Our ref: STH09/01787/45  
Contact: Hayley Sarvanandan 4221 2423  
Your ref: Land Use Plan

## **LAND USE PLAN – LOT 7 DP259137, 2514 ILLAWARRA HIGHWAY CALDERWOOD – PROPOSED REZONING AND ACCESS**

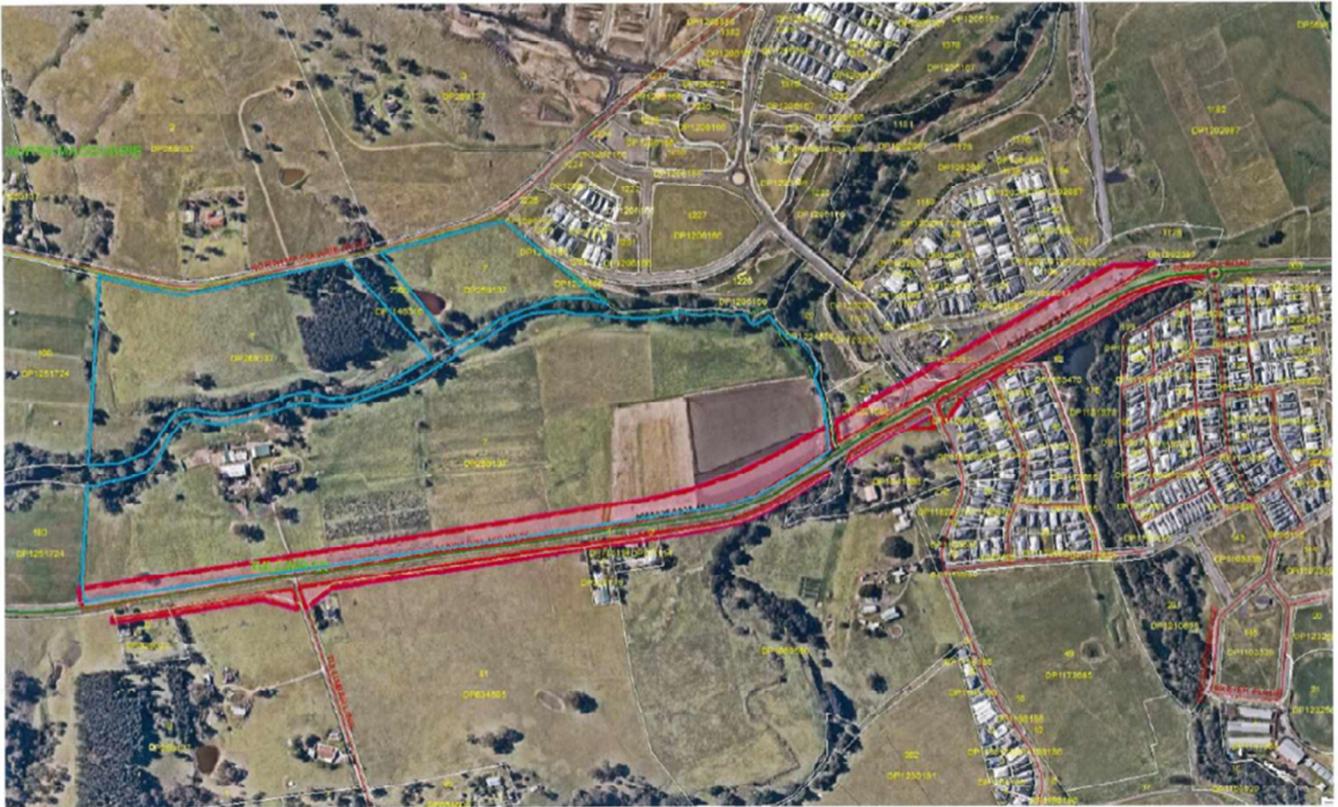
- The updated concept plan maintains the road widening strip along the Illawarra Highway zoned SP2 and provides a road connection to the adjoining Lot to the west (Lot 100 DP1251724). Following recent telephone discussions with Urbanco regarding the existing road widening; RMS reiterates that the road widening along the Illawarra Highway zoned SP2 must remain as shown in the current LEP (Attachment 3).

- The proposal seeks to construct a roundabout to provide access to the southern portion of the site and proposes an additional left in, left out arrangement to the east of the roundabout as shown in Attachment 1.

- RMS is willing to consider the proposed roundabout treatment for the intersection of Illawarra Highway and Tullimbar Lane. The proposal would need to be supported by a traffic analysis including modelling and a concept design which included details of the works proposed to support the change in speed zone required to allow a roundabout.

- RMS do not generally support multiple access points onto a classified road, an additional access would only be considered if it was demonstrated that utilising the proposed roundabout at the intersection of Tullimbar Lane and Illawarra Highway was not practical.

- RMS requires a concept design demonstrating the future road connectivity to the adjoining Lot to the west (lot 100 DP1251724) is constructible (i.e. in terms of vertical and horizontal alignment considering the constraints of the site) and suitable to accommodate additional traffic in the future.
- Identification and provision of appropriate infrastructure to support walking, cycling and public transport, both within the site itself and connecting to existing and/or proposed networks.
